# REQUEST FOR BIDDING INTERPRETATION (RFBI)

PMDB RFBI No.: 23

Project No.: 000000000008666  
Project Name: DSH-Coalinga Hydronic Loop Replacement  
Location: Coalinga, CA

Drawing Reference: Sheet S-3.00 Project Manual Reference: \_\_\_\_\_

4 DETAIL  
Scale: 1" = 1'-0" Ref:

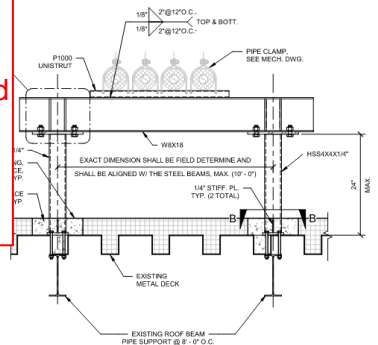
Question: Project Detail 4 on Sheet S-3.00 shows the anchor bolts for the pipe supports attaching to the existing roof beam (and below the metal pan deck). The detail also shows the anchor bolt stud being bolted below the top flange of the roof beam.

At the Contractor's discretion, can Detail 4 be substituted with Detail 1 on the same sheet?

Tapping the top flange of the beam will require cutting holes into the metal deck to locate the beam. The opening in the pan deck would need to be large enough to tighten the bolt under the top flange. Because this work would happen from the roof, debris may fall thru the ceiling and inspection of the bolts below the beam would be very difficult.

The Detail 4/S-3.00 is revised, find revised attached drawing
